AMENDMENT(S) TO THE DRAWINGS

REMARKS

Fig. 1

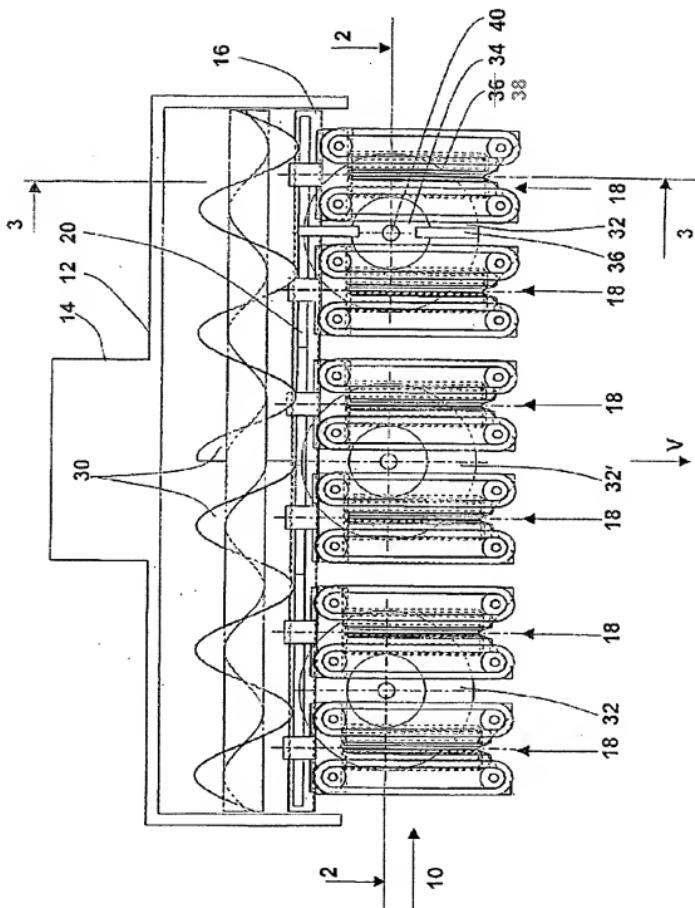
Please amend Fig. 1 as indicated in red on the attached Annotated Sheet. A Replacement Sheet presenting replacement figures which incorporate the desired changes is also enclosed in the Submitted Drawings section of this amendment.

Responsive to the objection to the drawings, Applicant has amended Fig. 1 and has corrected the drawing to properly notate and identify the envelope circles 38. Accordingly, Applicant submits that the drawings are now in allowable form, and do hereby respectfully request the withdrawal of the objection thereto.

The Abstract has been objected to because reference numeral 38 was not provided in the drawings. The drawing corrections discussed in the preceding paragraph have addressed this issue. Accordingly, Applicant submits that the Abstract is now in allowable form and respectfully requests that the objection be withdrawn.
